**REGULAR MEETING OF THE THIRD LAGUNA HILLS MUTUAL
ARCHITECTURAL CONTROL AND STANDARDS COMMITTEE**

**Monday, February 26, 2018 – 9:30 a.m.
Laguna Woods Village Community Center Sycamore Room
24351 El Toro Road**

DATE: February 26, 2018
FOR: Architectural Control and Standards Committee
SUBJECT: Variance Request
Mr. and Mrs. Richard and Heidi Penkava of 3191-D (La Reina, PL804RA)
Replace Existing Enclosed Rear Patio with Room Addition

FRAMING PLAN
SCALE 1/4"=1'-0"

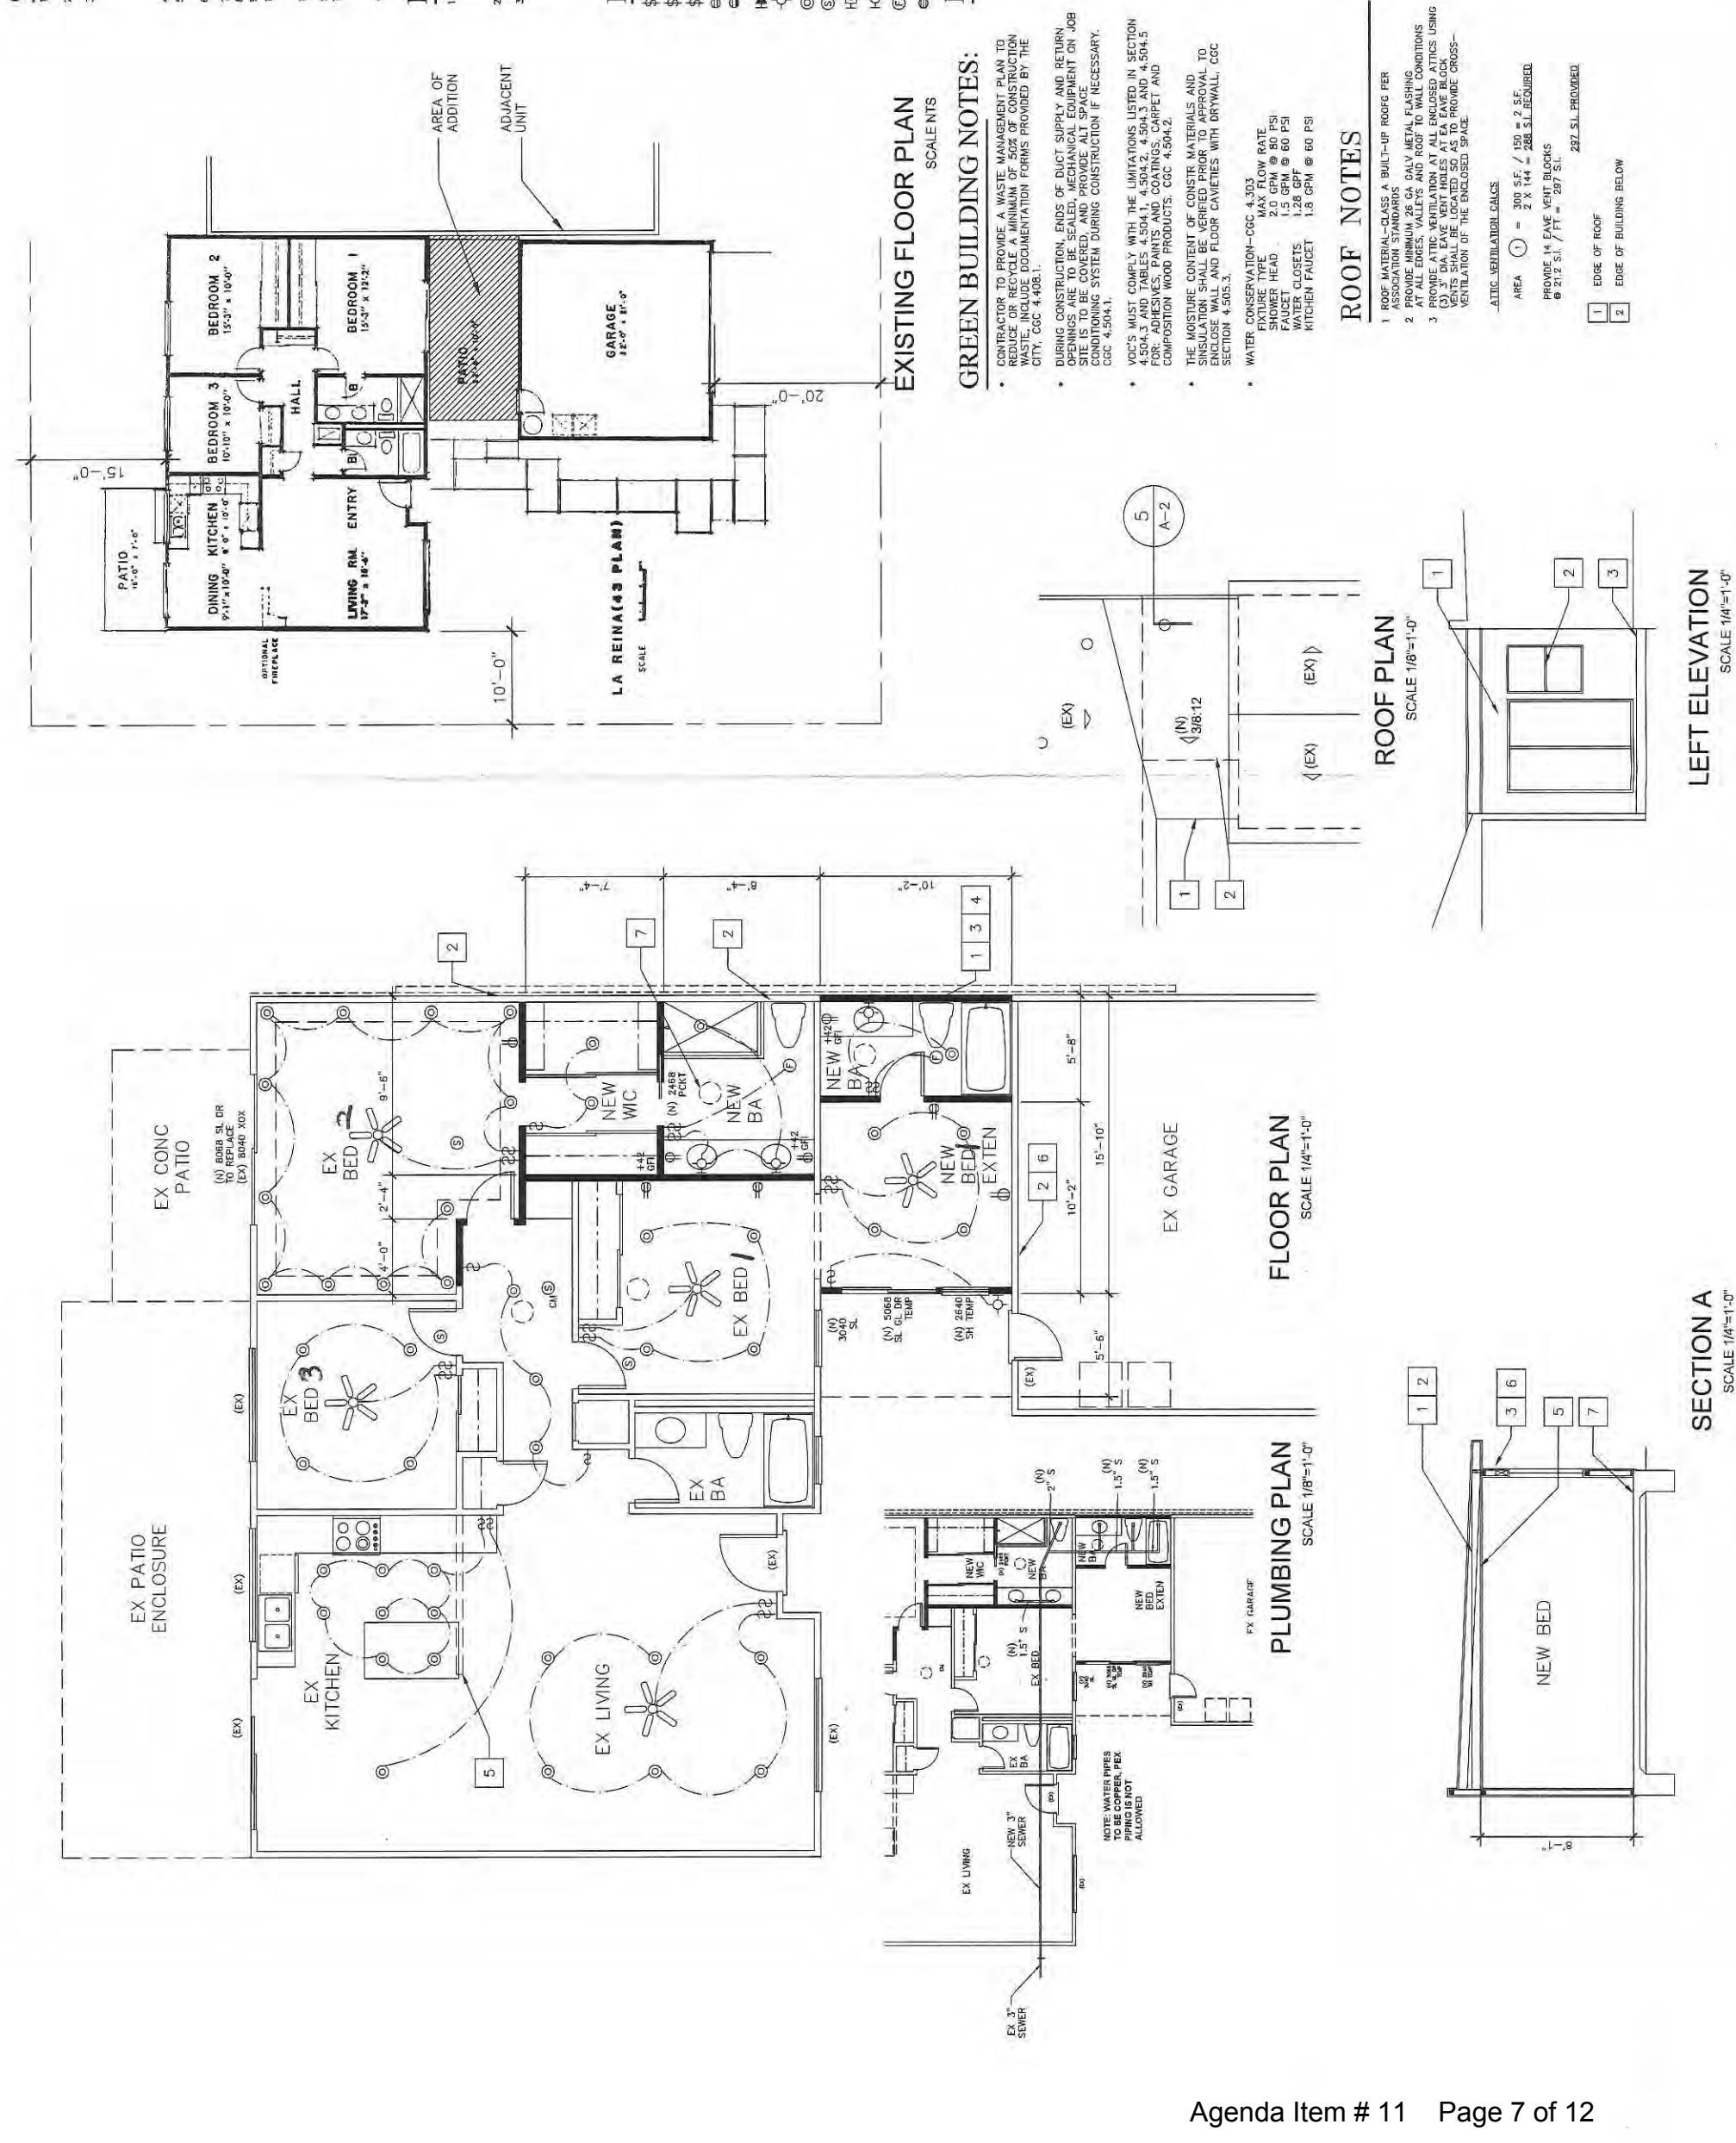
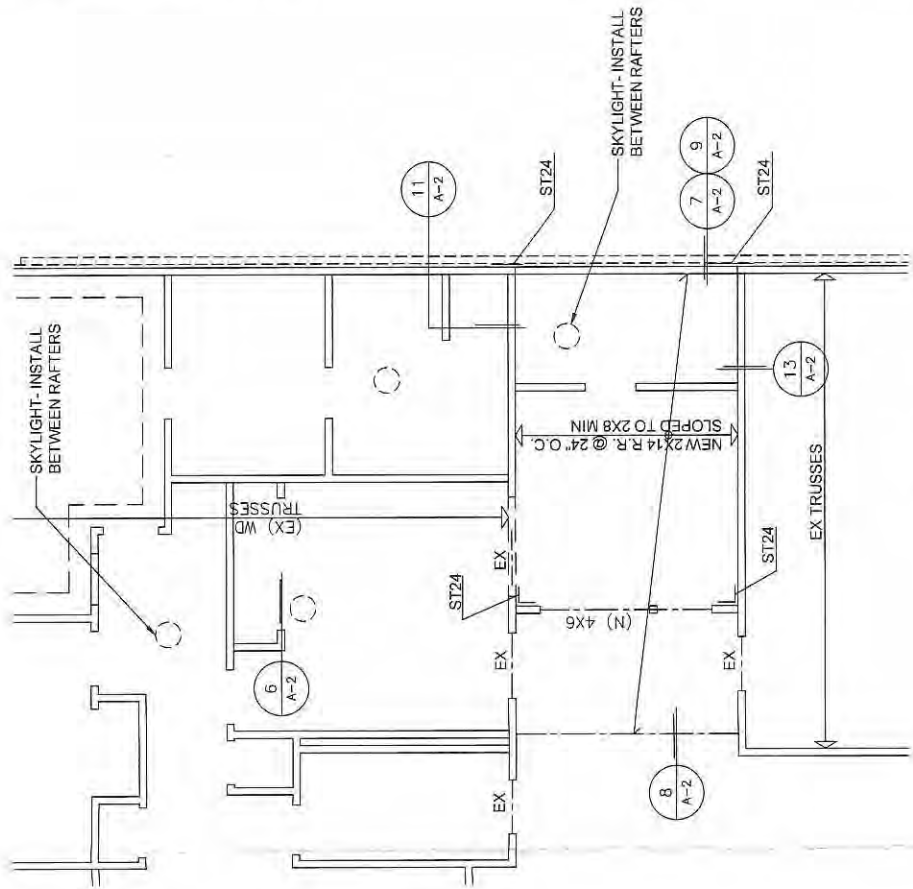
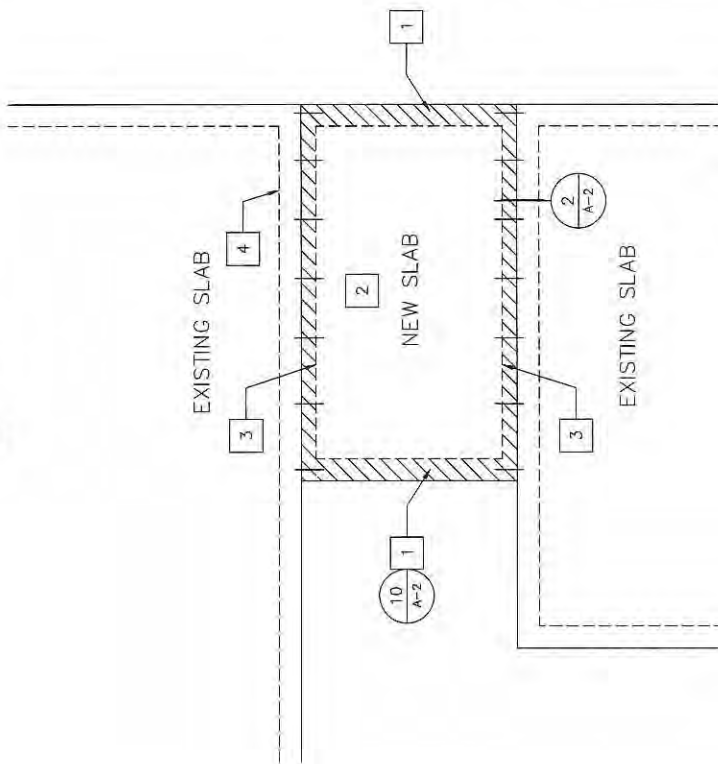
Mr. Wang proposes to enclose an area measuring 15 feet, 10 inches wide by 10 feet, 2 inches long on the front patio using wood frame and stucco to match the existing building exterior in order to add a bedroom extension to bedroom one with an en suite bathroom.

As part of a unit remodel that involves demolishing the existing en suite bathroom to Bedroom One and moving the bedroom into that area, Mr. Wang proposes to utilize the room addition to extend the relocated Bedroom One and provide an en suite bathroom that shares a common wall with Unit C.

A new 3 feet wide by 4 feet tall window will be installed on the relocated bedroom wall to provide for egress requirements.

The roof plans show a new built-up flat roof will be installed with a 3/8:12 pitch for drainage.

Plumbing plans have been provided showing the new bathroom areas will tie into a new 3 inch sewer line before tying into the existing line. A City permit will verify building codes are met.

2. A Mutual Consent for Manor Alterations has been granted at **3238-B** for **Room Addition on Front Patio**, subject to the attached plans stamped approved and is subject to the final inspection by the Division. Any variations to the approved attached plans are not allowed and could result in a stop work notice and/or severe fines to the Member.
